#### **TECHNICAL MEMORANDUM**

Subject: 501 Eye Street SW (ZC Case No. 17-21)

**Response to United Neighbors of Southwest Comments on CTR**

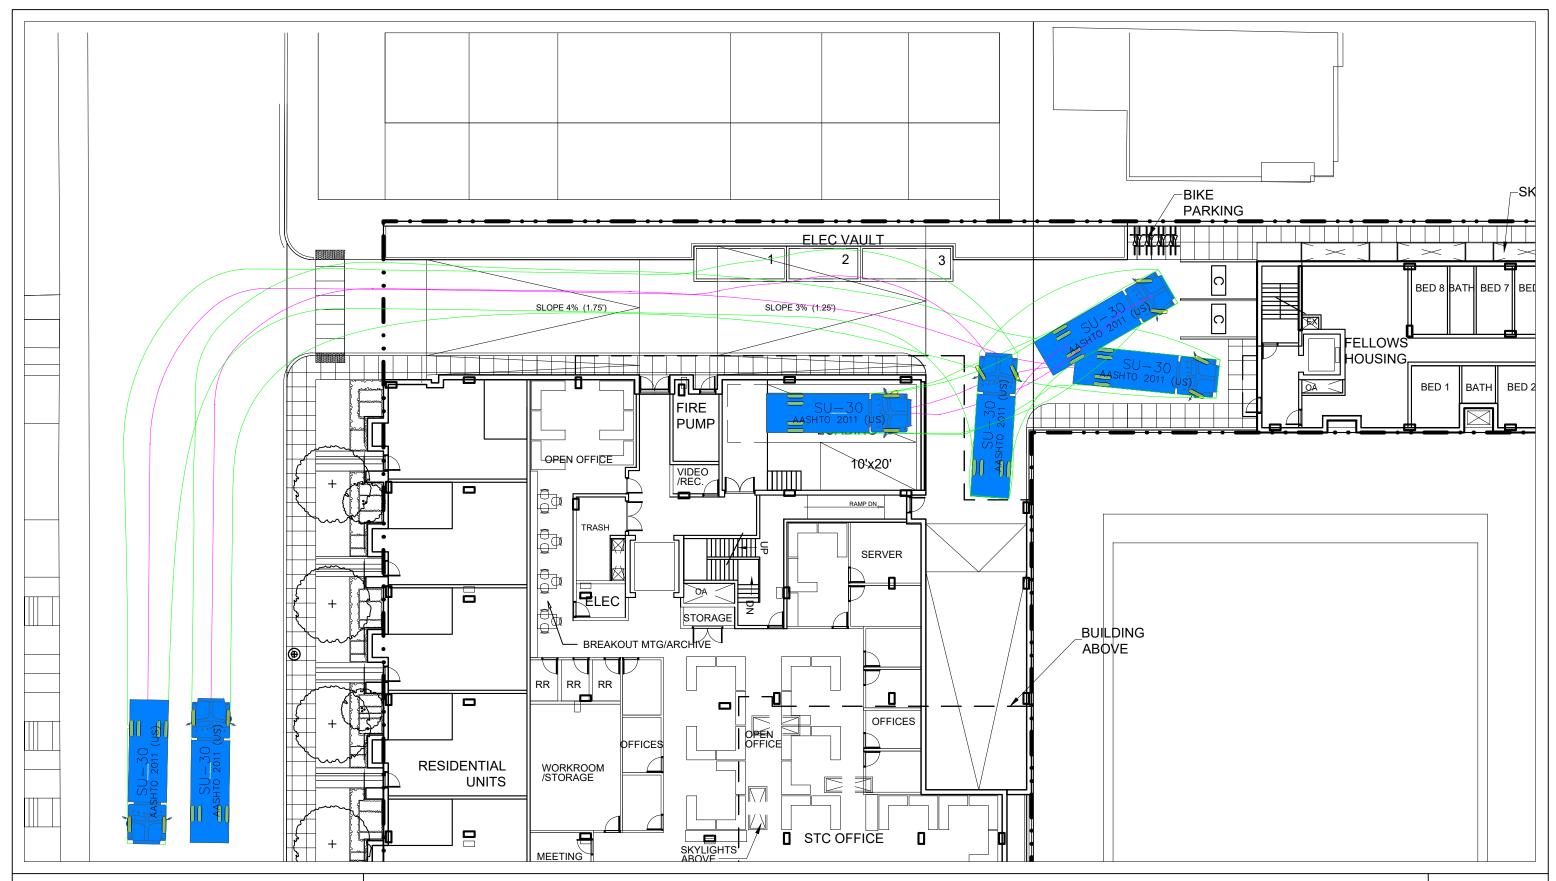
"Crash data analysis" (p. 63) "According to the Institute of Transportation Engineer's Transportation Impact Analysis for Site Development, a crash rate of 1.0 or higher is an indication that further study is required. One intersection in this study area met this criterion."

Table 17 shows two nearby intersections that each had five pedestrian crashes from 2015-2017 (and this was before the greatly increased traffic resulting from the opening of the Wharf and several other new developments in the area). This reinforces our concern about safety and the dangers of increased traffic, especially to children from the neighboring and nearby schools.

The data included in the analysis (2015-2017) is the most recent data available from DDOT. Although the CTR includes this crash data, the data is not detailed enough to determine the exact nature of each crash, particularly those involving pedestrians. Additionally, improvements at the intersection of  $4^{th}$  & M Street are being studied as part of the  $4^{th}$  & M Street SW Safety Study.

The Bard: Loading Review

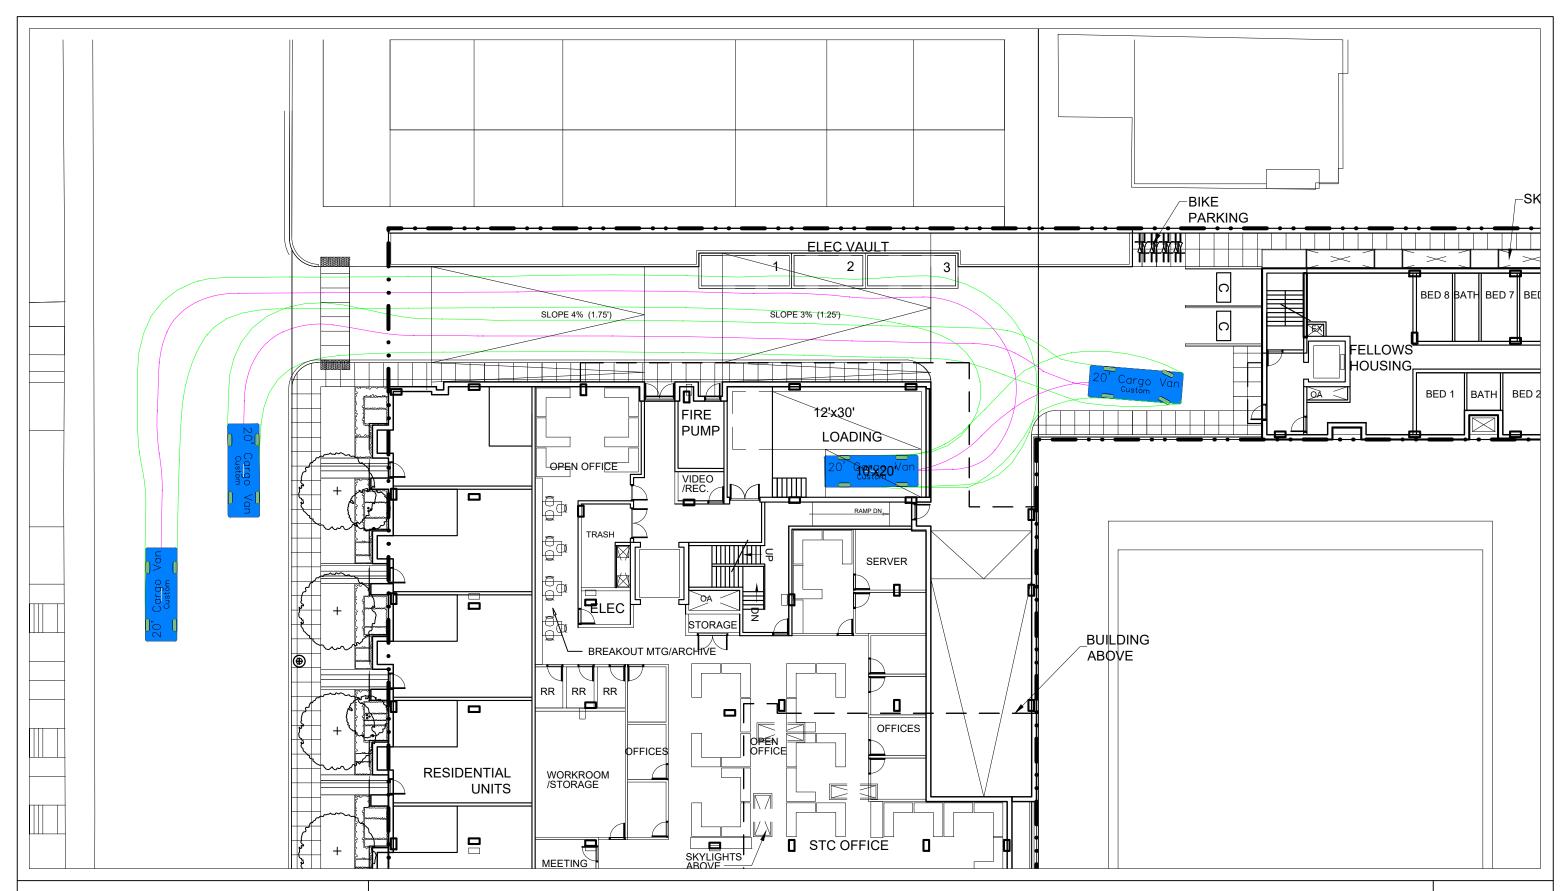
"The site is designed to accommodate head-in/head-out maneuvers into the proposed loading area, which includes a 30' loading berth and a 20' service/delivery space. Truck turning diagrams are included in the Technical Attachments." (p. 12)

No "technical attachments" were filed with the Zoning Commission as part of the CTR.

The head-in/head-out truck maneuvers described in the PUD would require extensive backing up for trucks, with the accompanying load beeping, right up to the property line next to a row of townhouses. The Office of Planning set-down report of January 19, 2018 explicitly said the transportation report should address these turning maneuvers, but the CTR has not done so and has not

As is customary, the technical attachments were not submitted into the Zoning Commission record, but they were filed with the District Department of Transportation at the same time as the CTR and they were provided to UNSW upon request. Additionally, the turning maneuvers have been included as an attachment to this memorandum.

To mitigate the impacts of loading activity, the Applicant has agreed to limit trash and recycling collection hours to 10:00 AM to 4:00 PM, Monday through Friday. No trash or recycling collection will occur on the weekends. All other deliveries and moving activities will be limited to 9:00 AM to 5:00 PM. Except in the case of an emergency, service vehicles shall be limited to 7:00 AM to 8:00 PM.

Additionally, a space within the garage has been reserved for costume shop deliveries, removing this delivery activity from the ground-floor loading area.
